Meadow Springs Pump Station Wells No. 1 and No. 2 RFCSP
Solicitation Number: CO-00637
Job No.: 22-6025

ADDENDUM 2
July 11, 2023

PLAT NO.	N/A
JOB NO.	11650-00
DATE	MARCH 2023
DESIGNER	RG
CHECKED LN	DRAWN AL
SHEET	C2.01

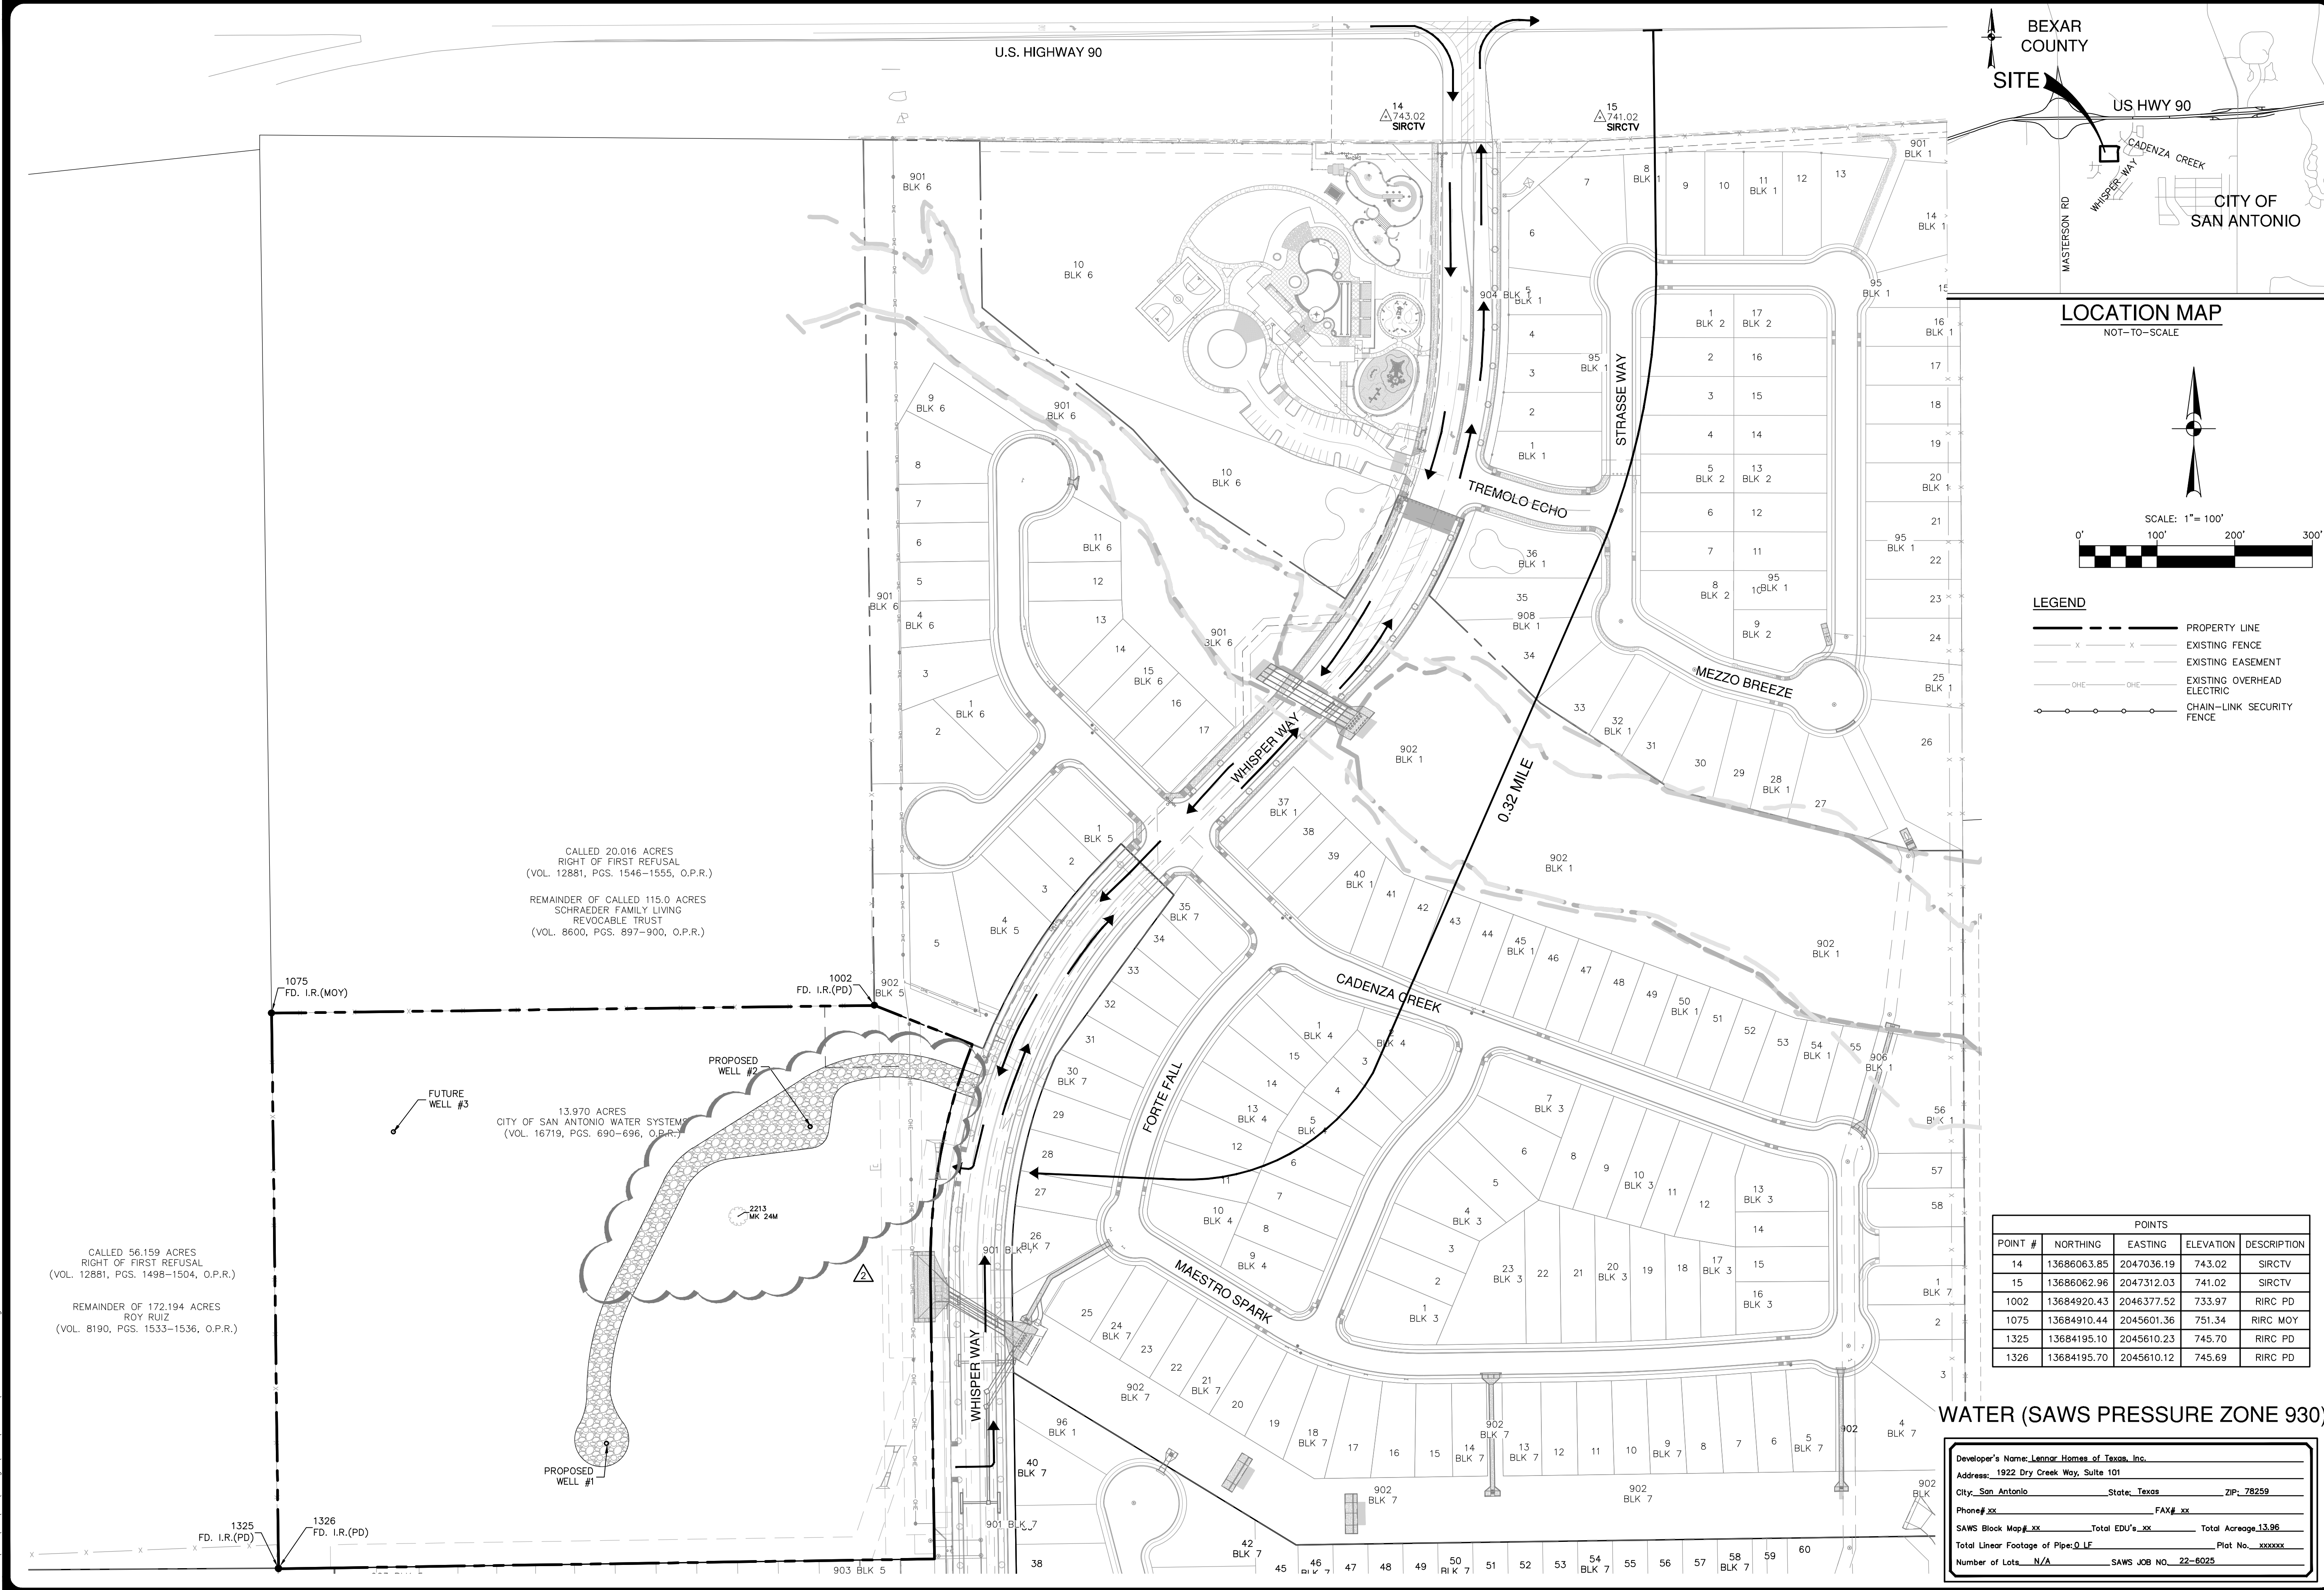
Response: Contractor will be required to make a connection to the existing SAWS fire hydrant along Whisper Way approximately 175' south of the project site. Refer to revised sheet C2.01 attached to this Addendum. Contractor shall make application to SAWS for installation of a standard fire hydrant meter in accordance with current SAWS Utility Service Regulations.

5. Can the location of the project access road be changed to the existing driveway cut?
Response: Yes, see revised drawings C2.01, C2.02, C3.01, C4.01, C6.01, and C6.02 attached to this Addendum.

1. C0.00 Addendum #2 - Add sheet C7.03 to drawing list.
2. C2.01 Add Addendum #2 items, revised entrance location, identify potable water source location. Remove Sheet C2.01 in its entirety and replace with the Revised Sheet attached to this Addendum.
3. C2.02 Add Addendum #2 – revised entrance location and gravel drive alignment. Remove Sheet C2.02 in its entirety and replace with the Revised Sheet attached to this Addendum.
4. C3.01 Add addendum #2 – revised entrance location and gravel drive alignment. Remove Sheet C3.01 in its entirety and replace with the Revised Sheet attached to this Addendum.
5. C4.01 Add Addendum #2 – revised entrance location, revise gravel drive alignment, add clearing limits for vegetation. Remove Sheet C4.01 in its entirety and replace with the Revised Sheet attached to this Addendum.

PLAT NO.	N/A
JOB NO.	11650-00
DATE	MARCH 2023
DESIGNER	RG
CHECKED LN	DRAWN AL
SHEET	C3.01

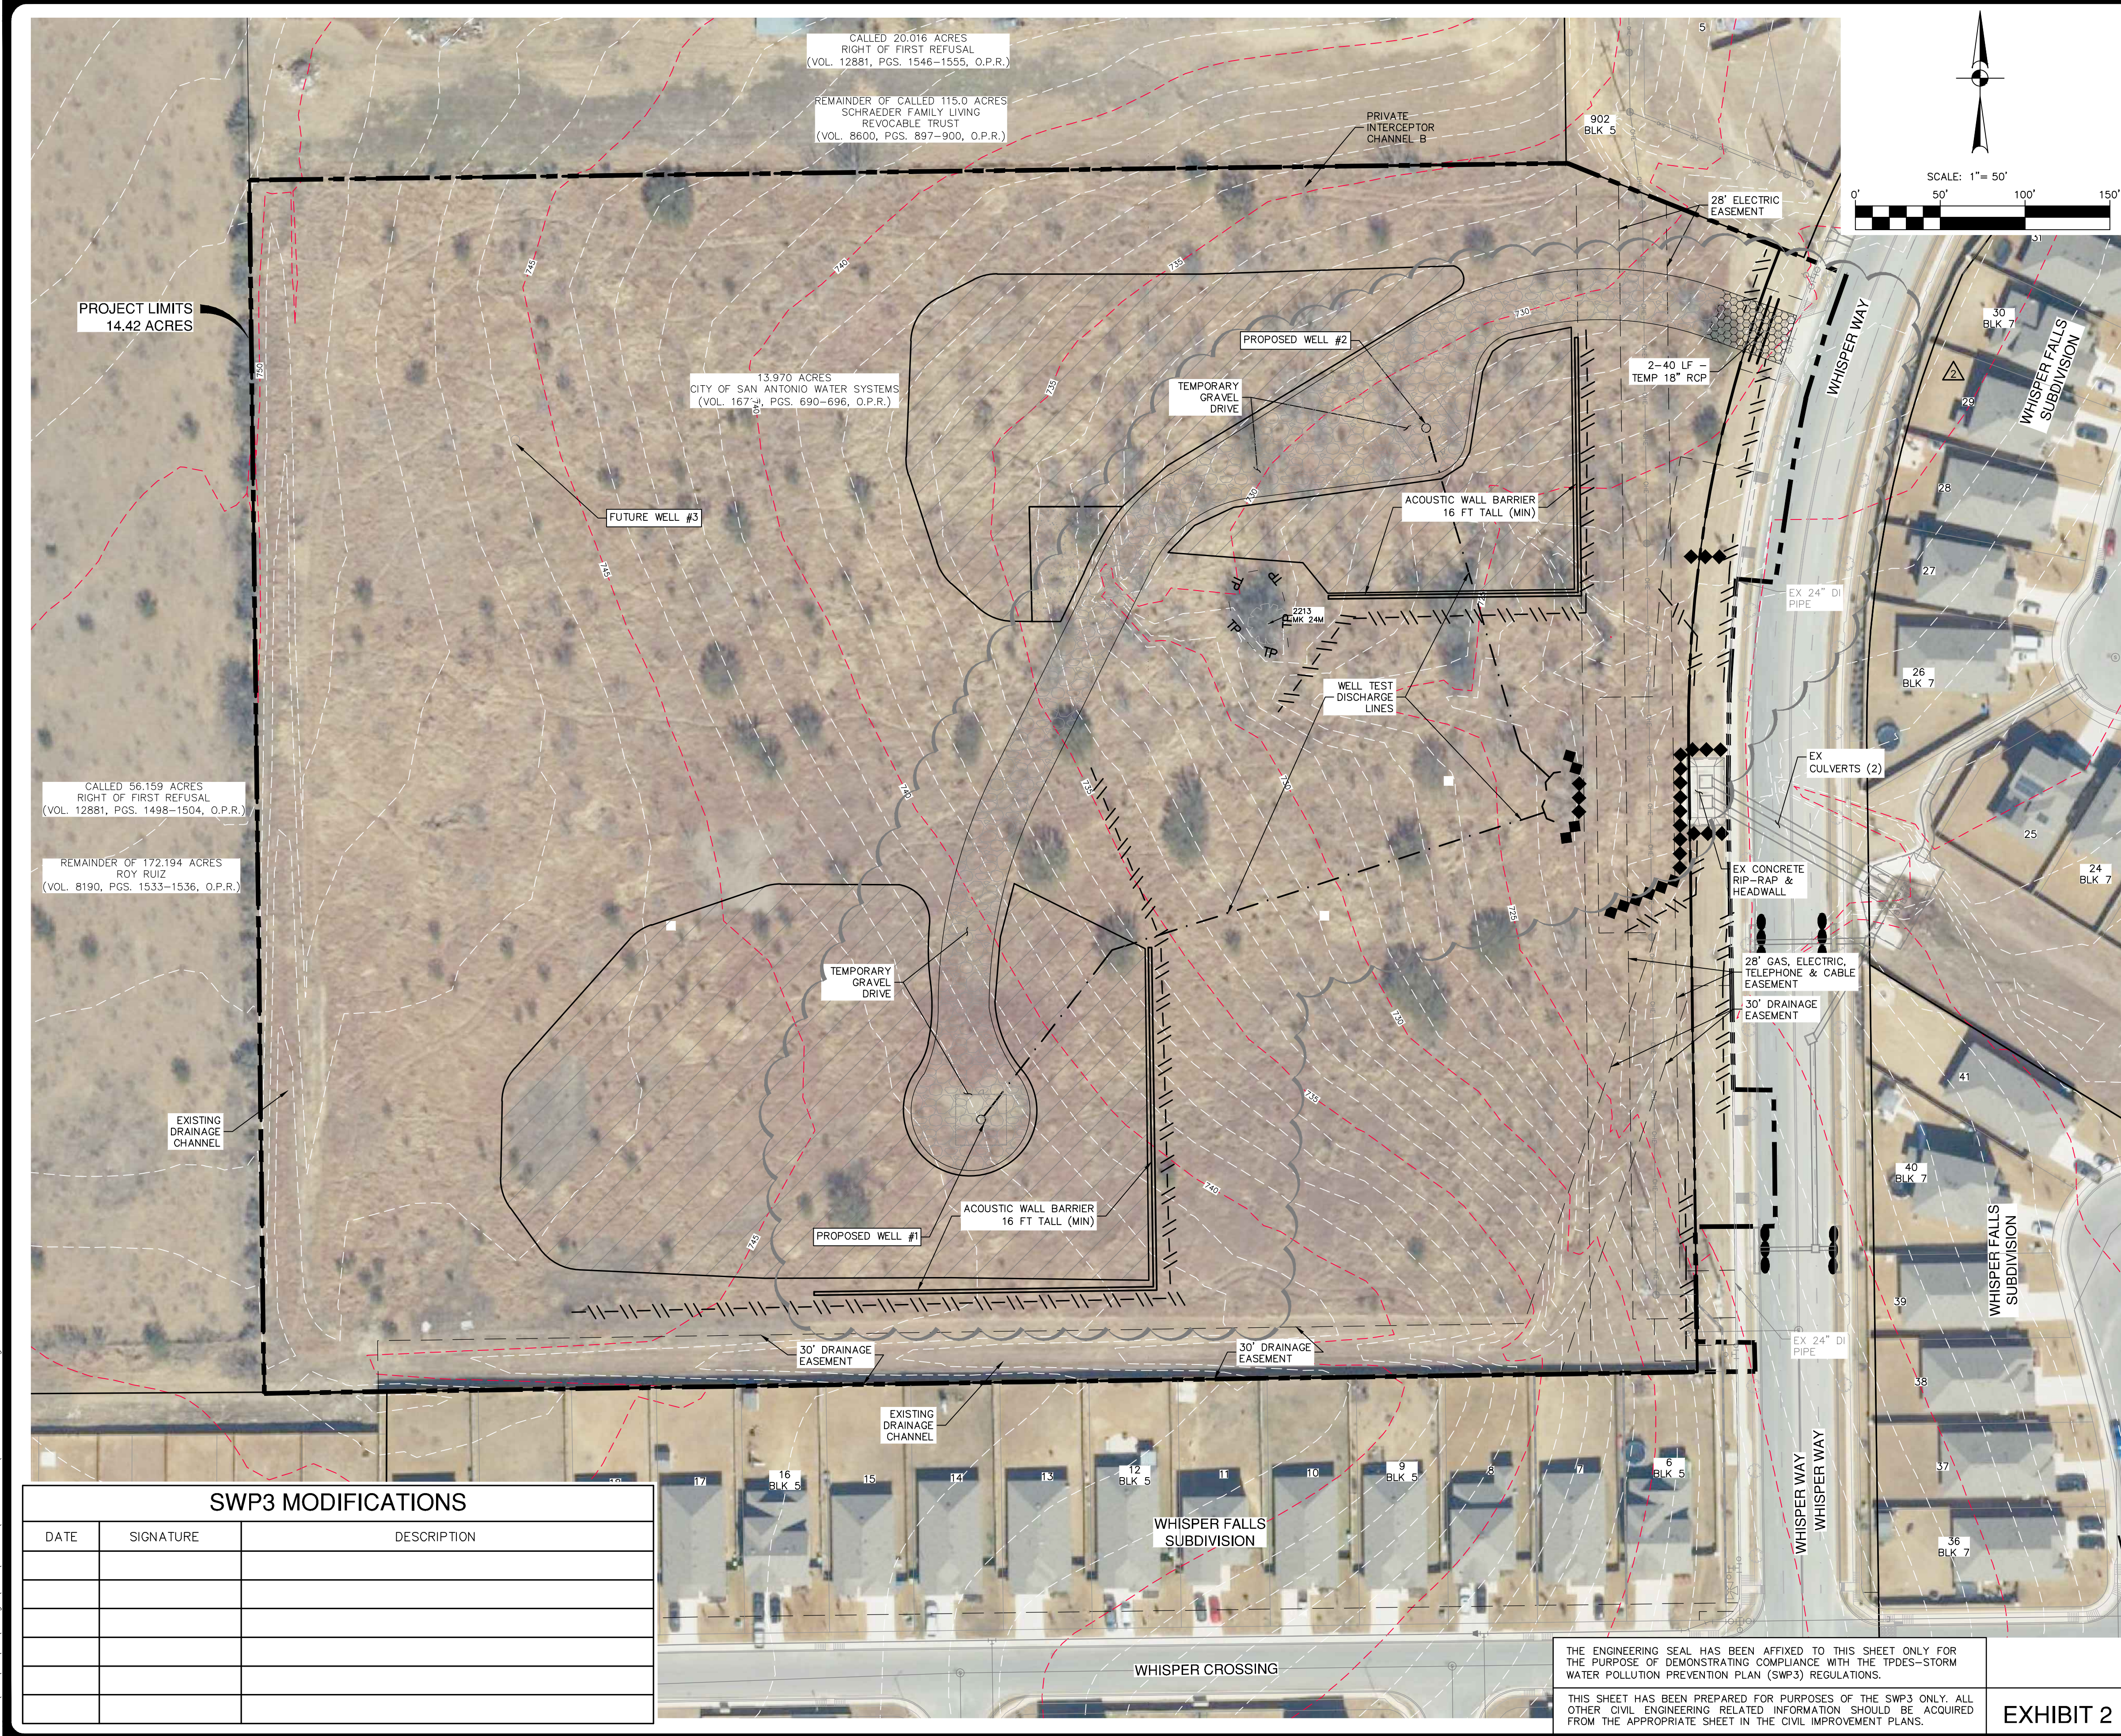
8. Please identify the preferred discharge point for the Pumping Test Discharge Water on the Site Plans.
Response: Refer to Sheet C3.01. Both well test discharge lines are to extend to the new rock berm shown on Sheet C3.01 west of the existing concrete culvert structure. Alignment and size of the well test discharge lines are responsibility of the Contractor.
